**MINERALS PROGRAM INSPECTION REPORT**  
**PHONE: (303) 866-3567**

<b>MINE NAME:</b> Siskin	<b>MINE/PROSPECTING ID#:</b> M-1987-116	<b>MINERAL:</b> Stone	<b>COUNTY:</b> Custer
<b>INSPECTION TYPE:</b> Preoperation Inspection	<b>WEATHER:</b> Clear	<b>INSP. DATE:</b> May 1, 2024	<b>INSP. TIME:</b> 10:45
<b>OPERATOR:</b> Colorado Quarries Inc	<b>OPERATOR REPRESENTATIVE:</b> Aaron Tezak	<b>TYPE OF OPERATION:</b> 110c - Construction Limited Impact	
<b>REASON FOR INSPECTION:</b> Preoperation Inspection	<b>BOND CALCULATION TYPE:</b> None	<b>BOND AMOUNT:</b> \$30,700.00	
<b>DATE OF COMPLAINT:</b> NA	<b>POST INSP. CONTACTS:</b> None	<b>JOINT INSP. AGENCY:</b> None	
<b>INSPECTOR(S):</b> Amber M. Gibson	<b>INSPECTOR'S SIGNATURE:</b> 	<b>SIGNATURE DATE:</b> May 10, 2024

Siskin was inspected by Amber Gibson with the Division of Reclamation, Mining and Safety (Division/DRMS) as part of a pre-operational inspection for a Conversion to a 112c revision no. 1 (CN1) application. Aaron Tezak (representing the Applicant/Operator – Colorado Quarries, Inc.) accompanied me during the inspection. The weather was warm and clear. This site was last inspected on February 12, 2020.

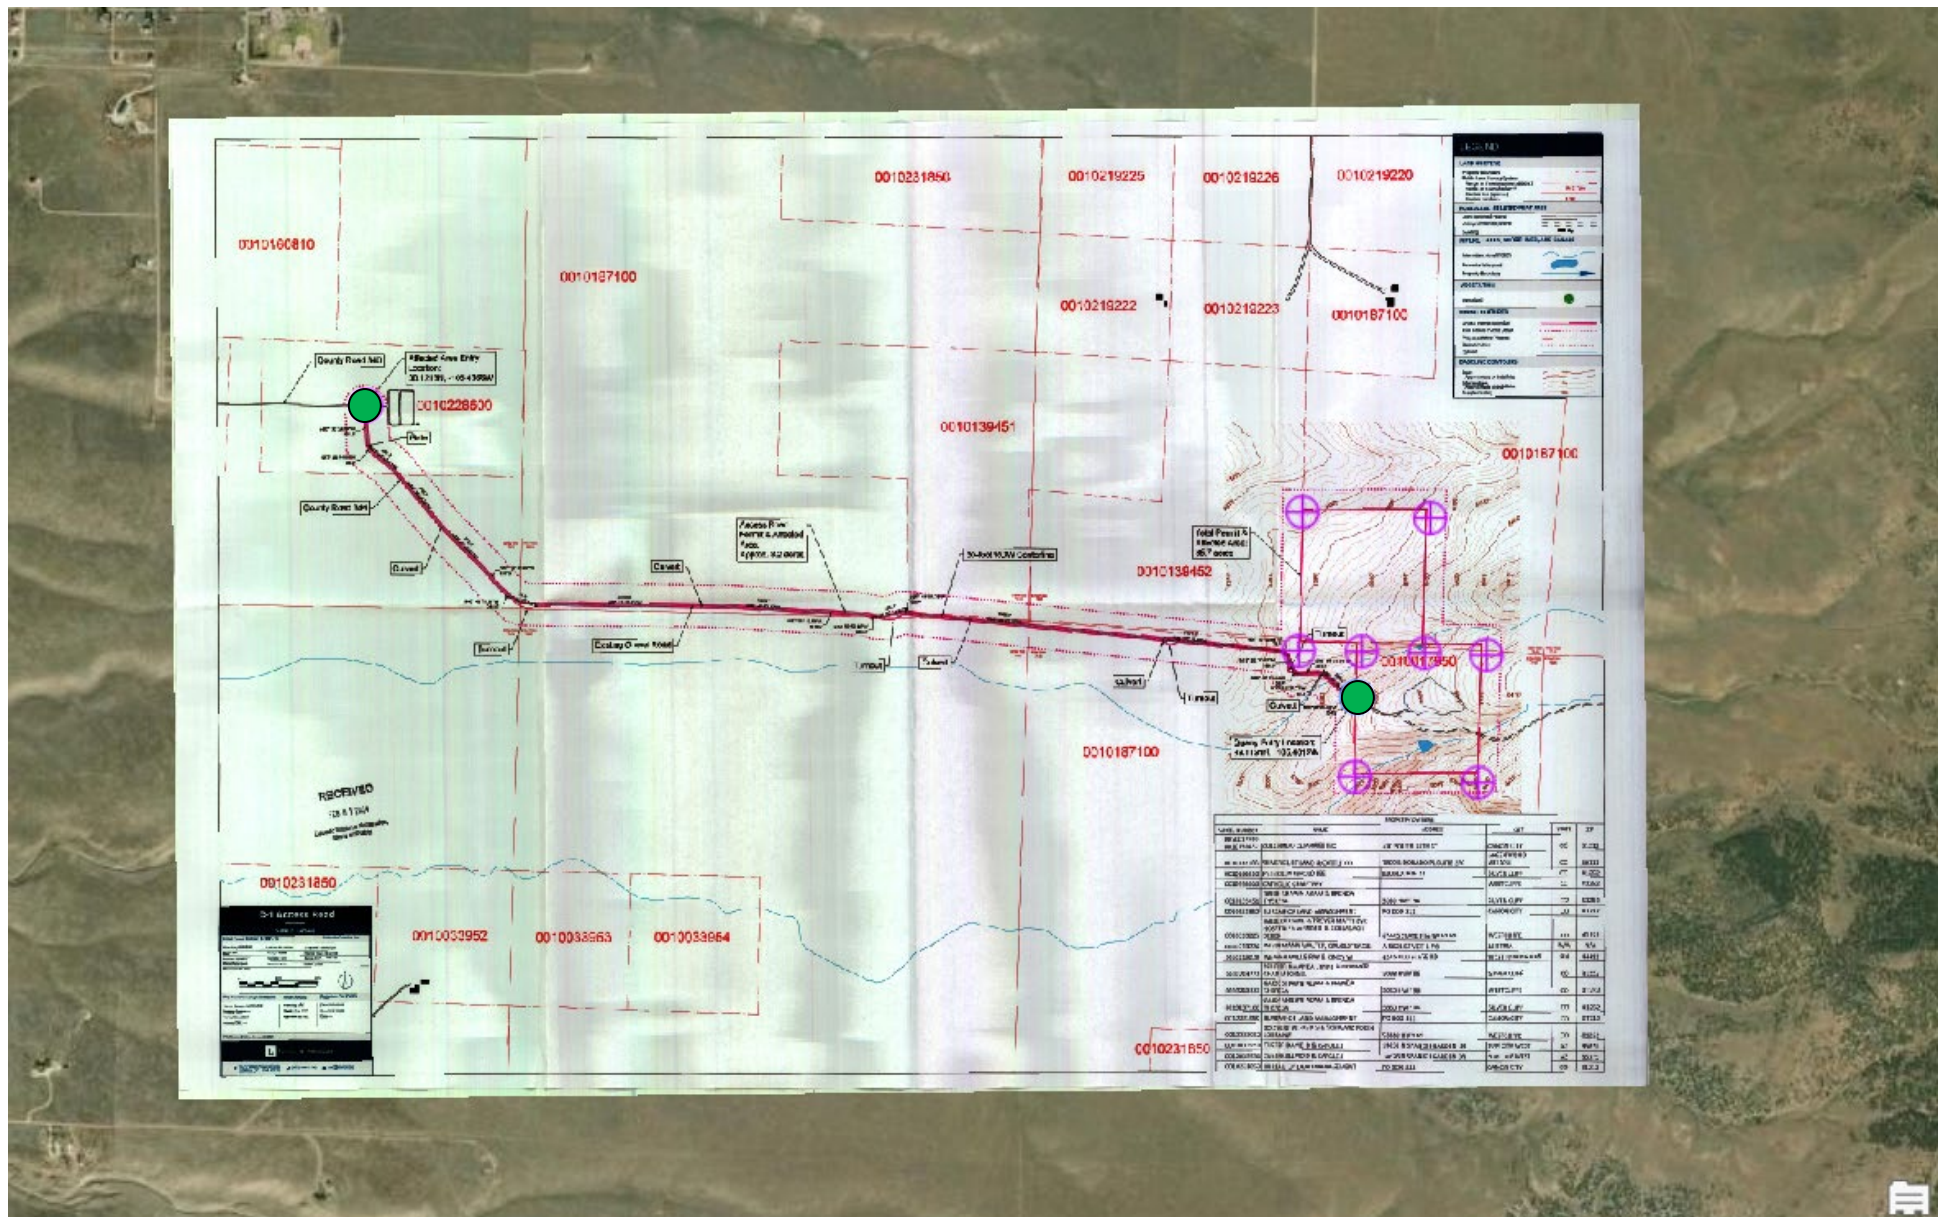
The Applicant had placed boundary markers around the proposed mining area prior to the inspection. The Applicant and the Division located each of the erected markers and collected approximate coordinates using the Esri Field Maps application (See Figure 1). The markers appear to be placed within this area in the orientation reflected on the maps in the CN1 application. Once approved, and prior to operation, the Applicant shall also place markers along the access road to be in compliance with Rule 3.1.12(2). During the inspection, the Applicant stated that they plan to install additional markers for line-of-sight, pit boundaries, and set-backs during each phase, upon approval of CN1.
